Subject: AP1000 Response to Request for Additional Information (SRP3.7.1)

Response to Request for Additional Information on SRP Section 3.7.1

AP1000 TECHNICAL REPORT REVIEW

RAI Response Number: RAI-SRP3.7.1-SEB1-02
Revision: 1

Figure RAI-SRP3.7.1-SEB1-08-1: Auxiliary building S.E. Corner Elevation 135'

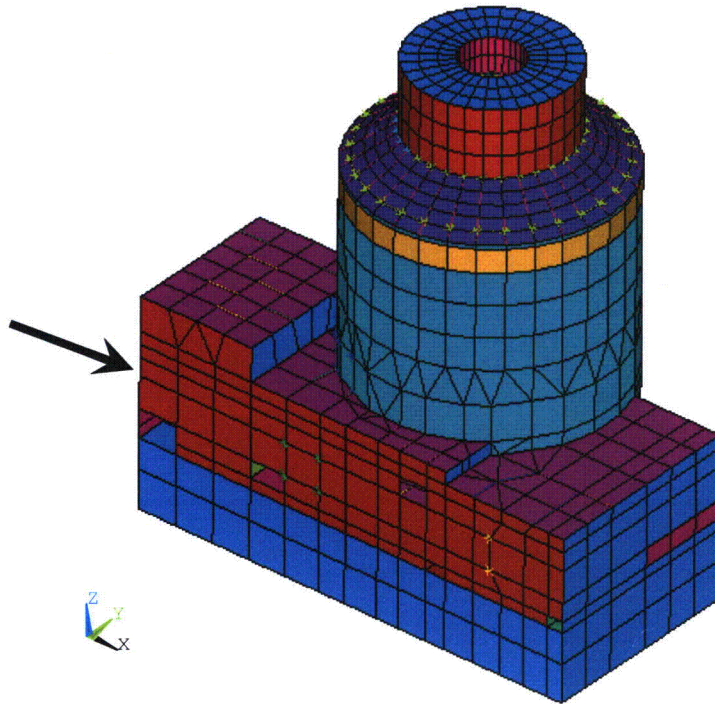
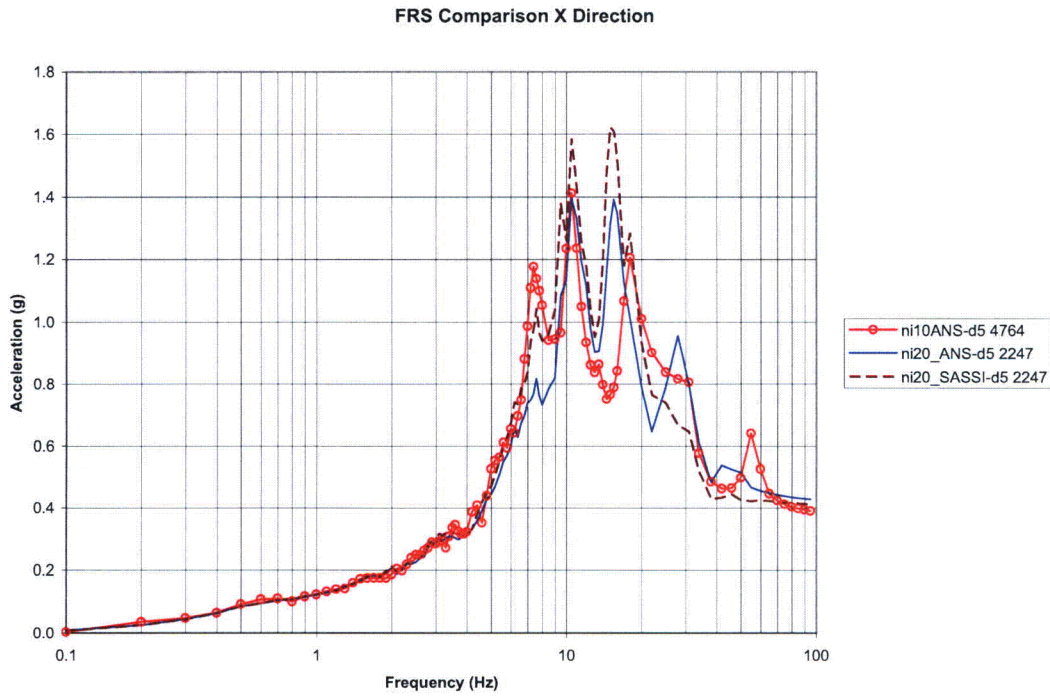
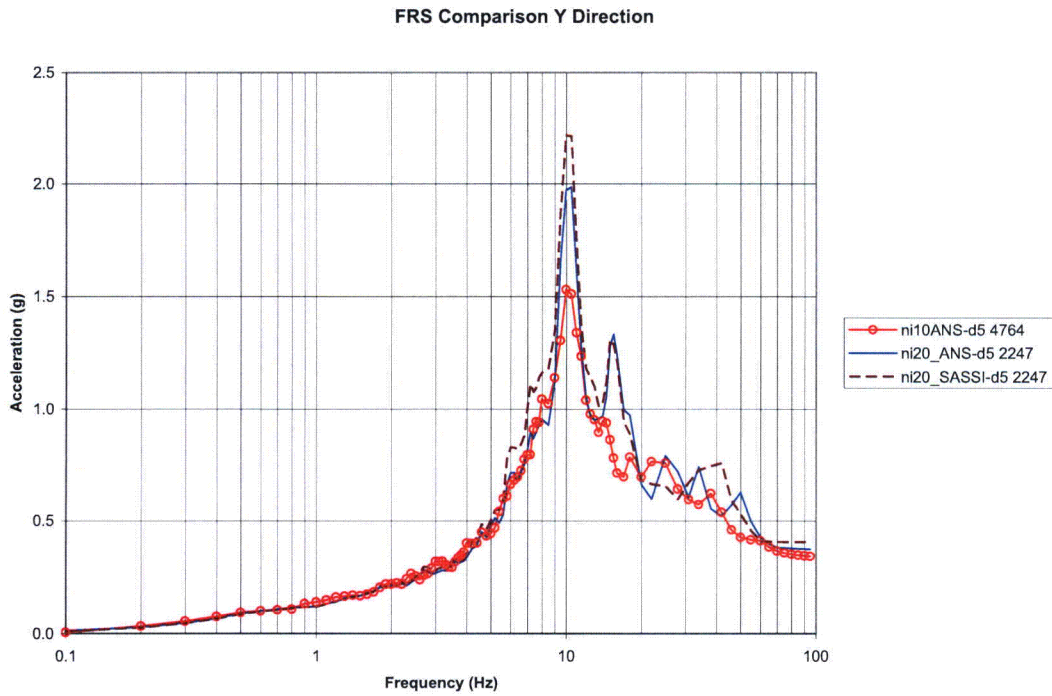
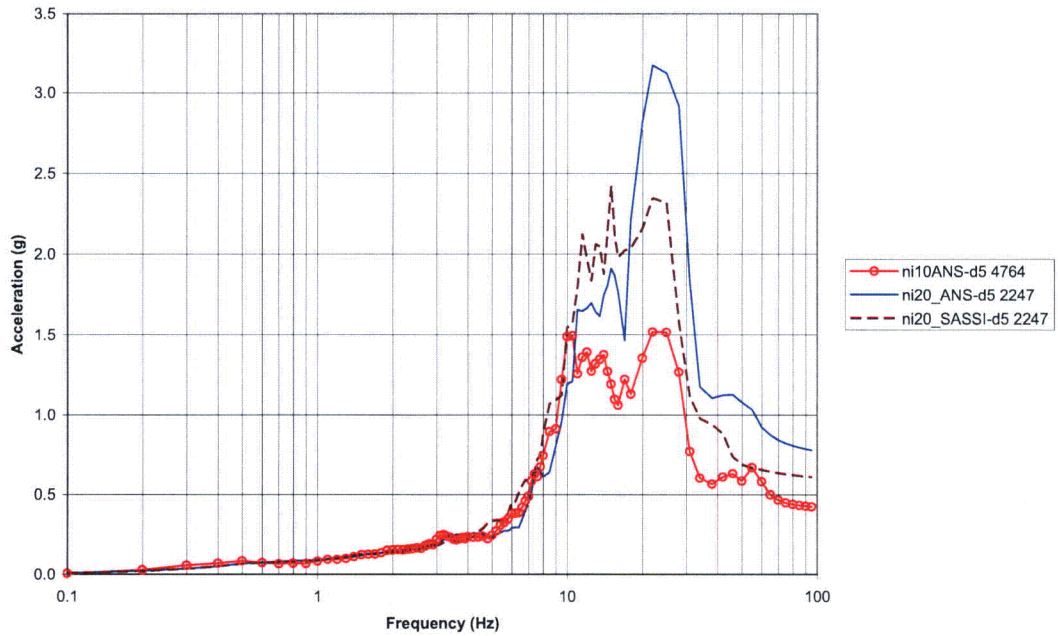
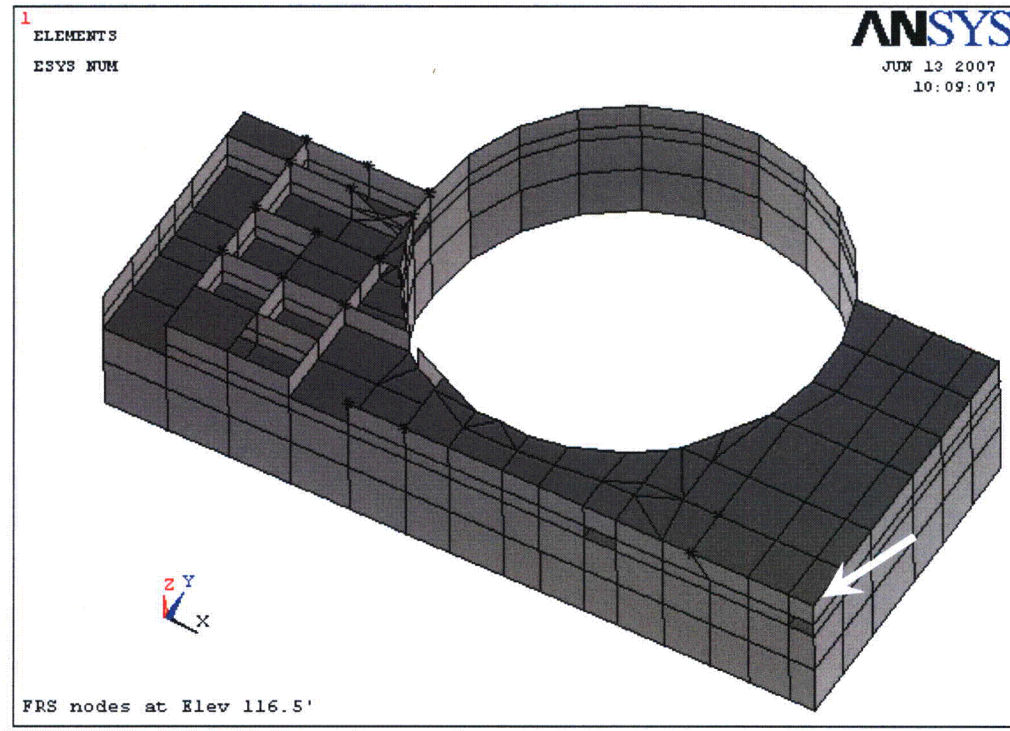
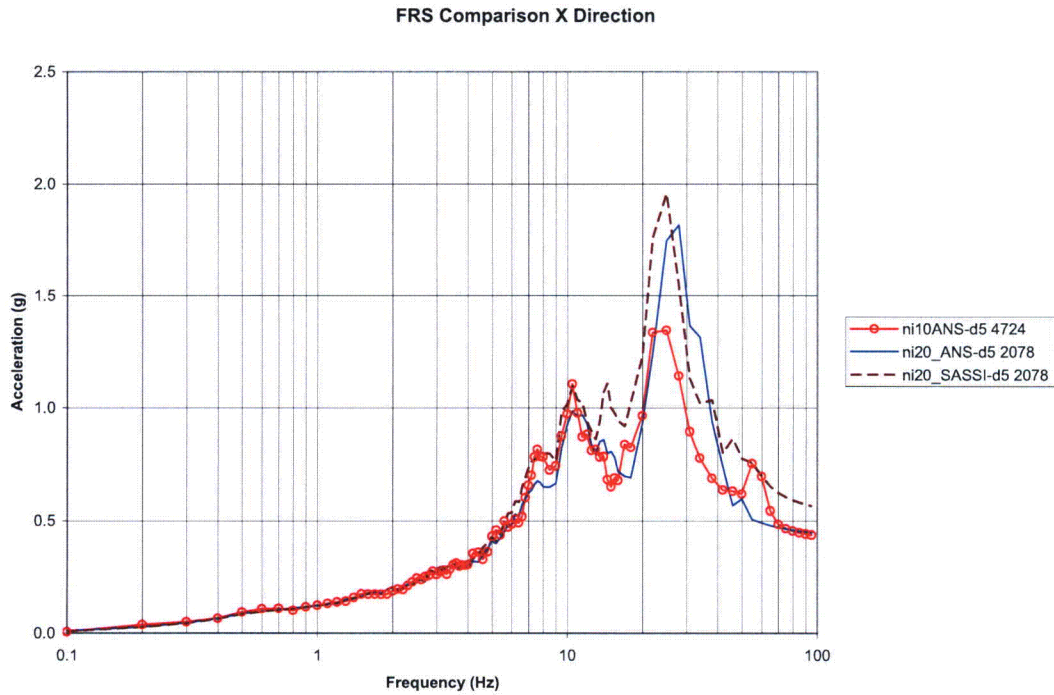
The staff also noted that there are an insufficient number of comparisons presented in TR-115 Section 5.1. The NI10 results presented show no significant amplification in the higher frequency range on any of the figures. The staff requests that Westinghouse include in Section 5.1, NI10 vs. NI20 comparisons at locations/directions where there is significant amplification at higher frequency.

In the meeting on May 19-23, 2008, it was requested by the NRC to provide additional spectra focused on the amplification at higher frequencies in the NI10 results when compared to the NI20 model results. Figures RAI-SRP3.7.1-SEB1-08-1 to RAI-SRP3.7.1-SEB1-08-8 show the locations and response spectra of the additional nodes for which floor response spectra comparisons are provided.

None The figures provided, RAI-SRP3.7.1-SEB1-08-1 to RAI-SRP3.7.1-SEB1-08-8, will be added to Section 5.1 of the TR-115 as Figures 5.1-4 and 5.1-5. Note that each figure will show the node location and the floor response spectra for the X, Y and Z locations.

RAI-SRP3.7.1-SEB1-09-01a: ASB at Elevation 327.4' X Direction

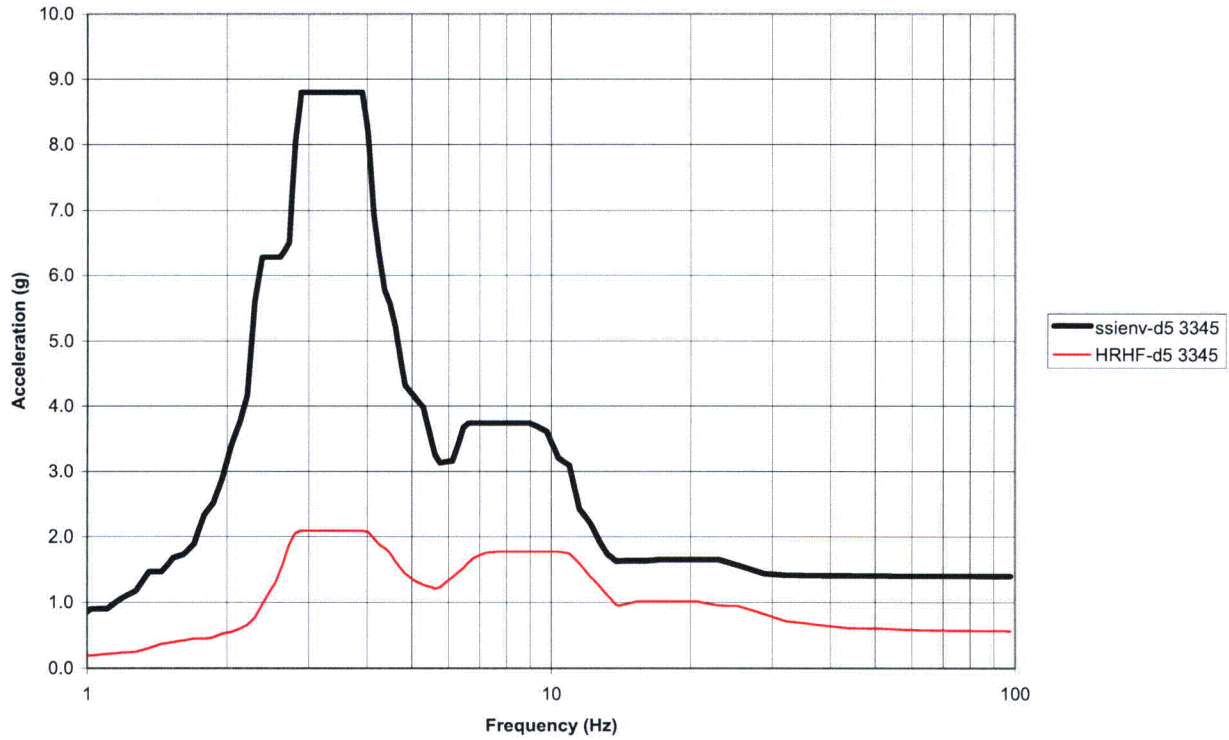
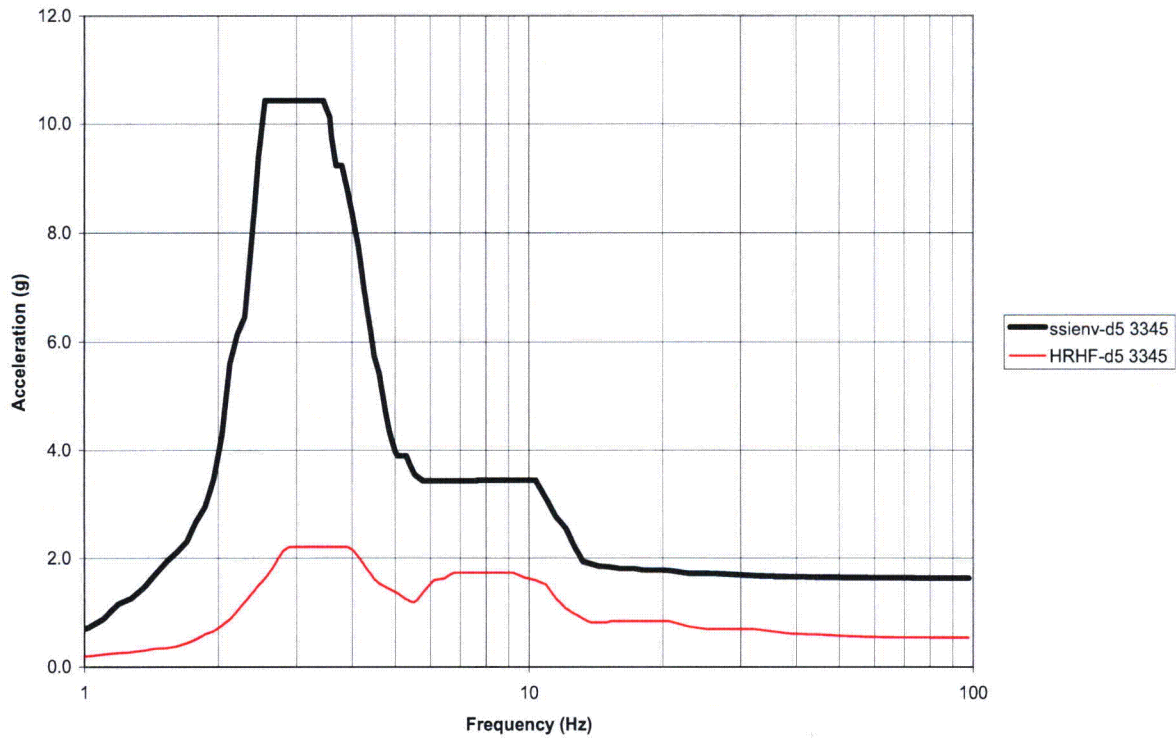
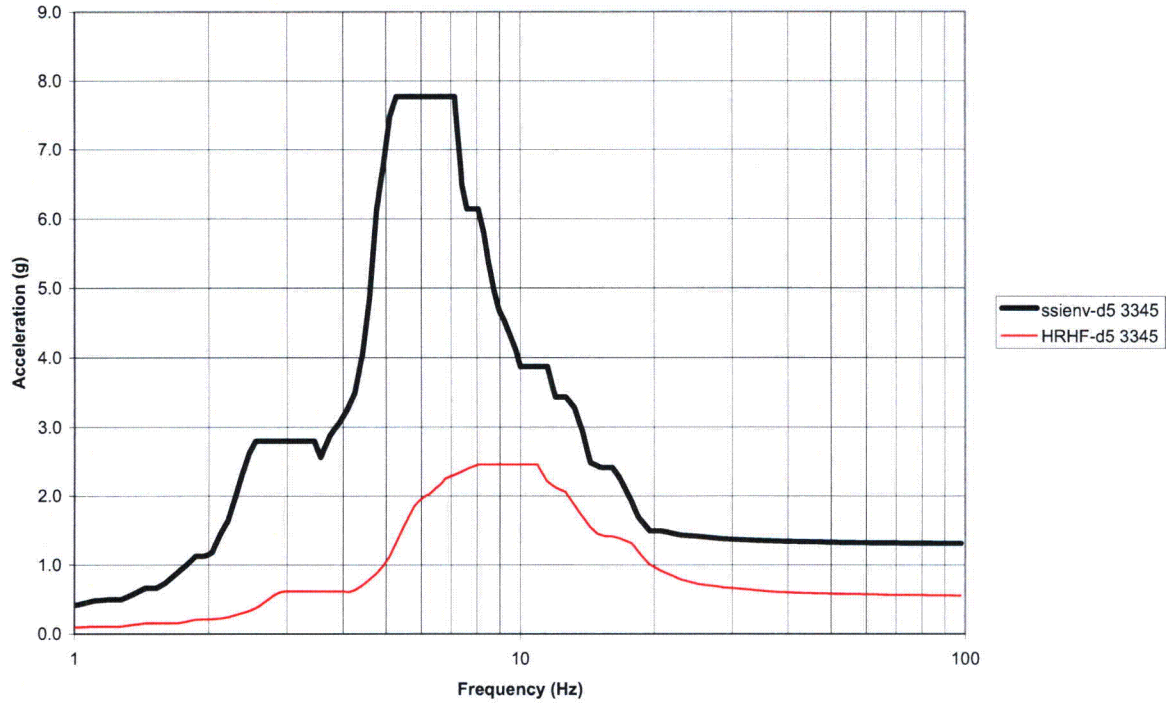
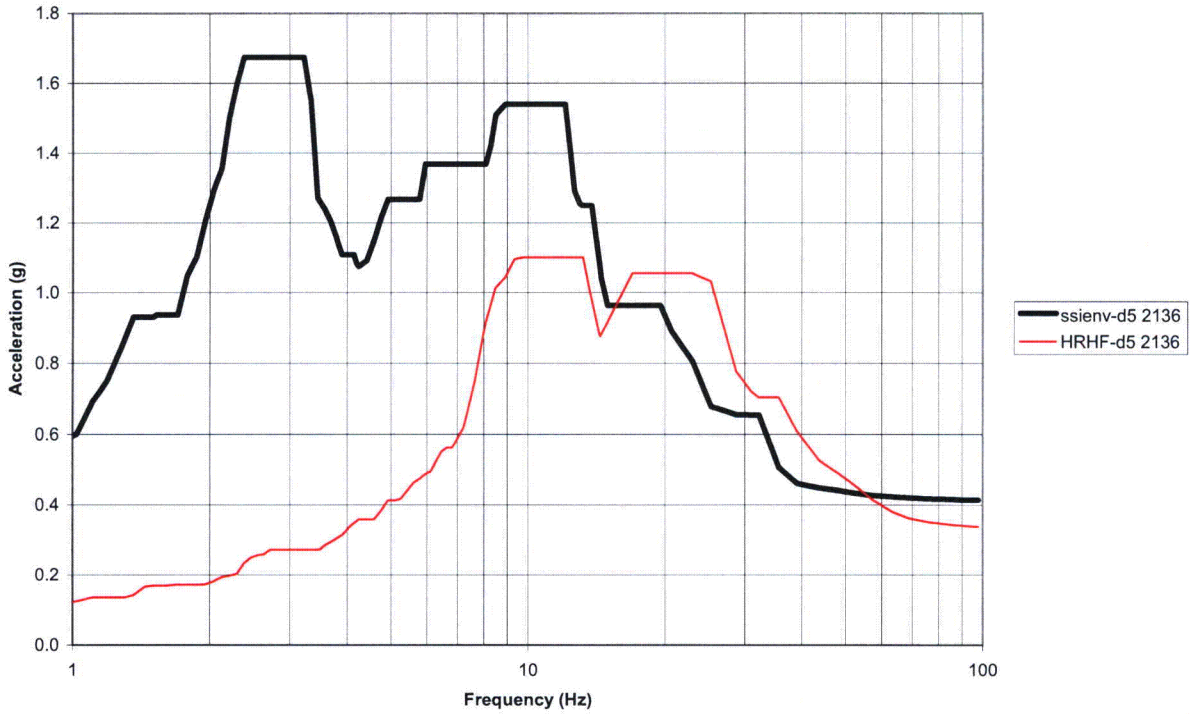
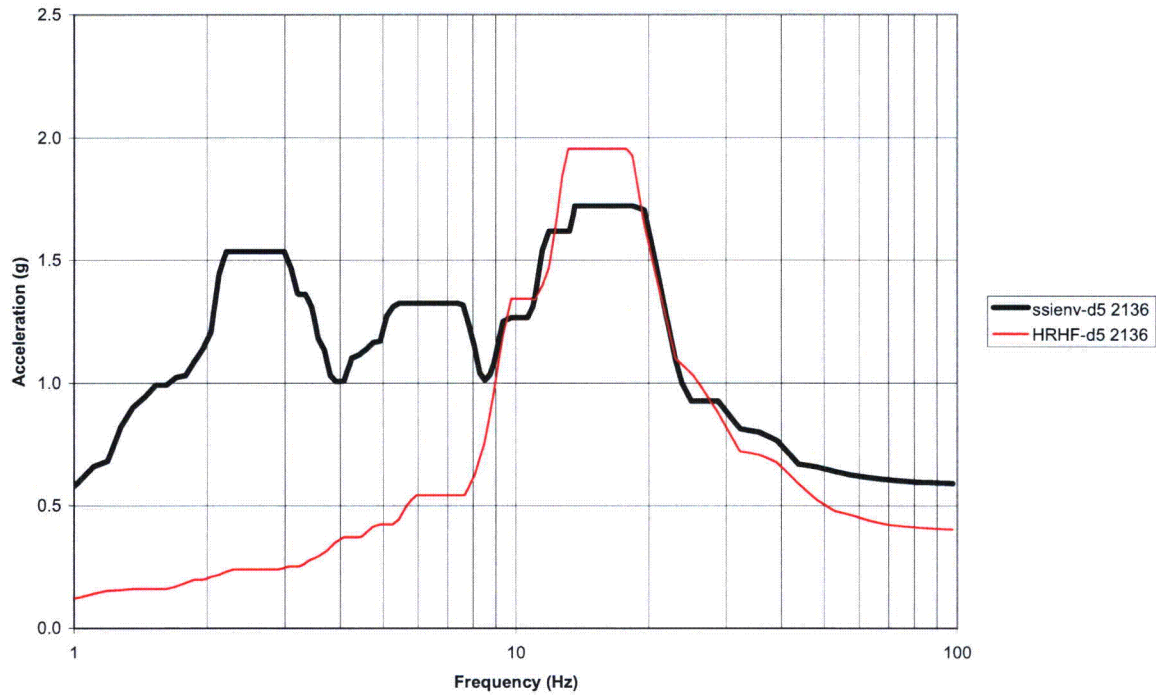
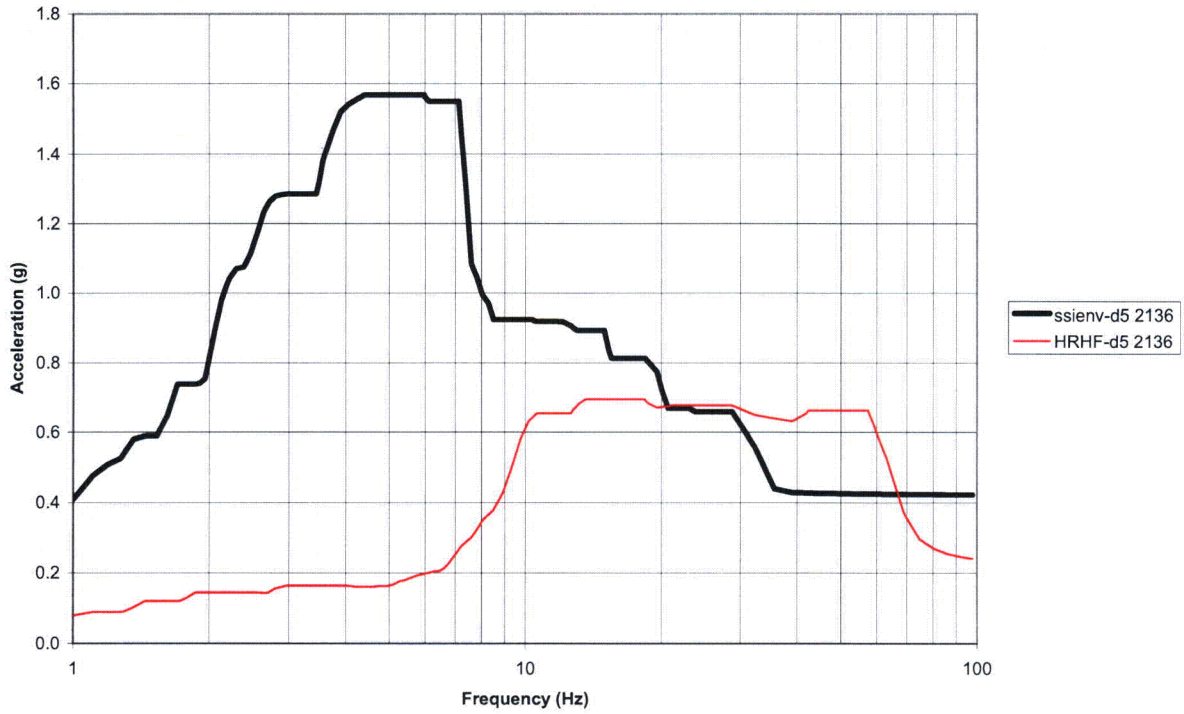
The staff noted that improved, more readable Figures 5.2-1 through 5.2-6 in TR-115 are needed. The ordinate scale and the legend cannot be read even by zooming in the electronic file. High resolution printing makes them barely readable. The staff requests that Westinghouse submit larger, readable copies of Figures 5.2-1 through 5.2-6, to facilitate the staff's evaluation of the information.

The requested figures are found in Figures RAI-SRP3.7.1-SEB1-09-01a to RAI-SRP3.7.1-SEB1-09-06c. These figures will replace the Figures 5.2-1 through 5.2-6 in the next revision to TR-115. See also RAI-SRP-3.7.1-SEB1-10 and RAI-SRP-3.7.1-SEB1-11.

Figures RAI-SRP3.7.1-SEB1-09-01a to RAI-SRP3.7.1-SEB1-09-06c will replace Figures 5.2-1 through 5.2-6 in the next revision to TR-115.
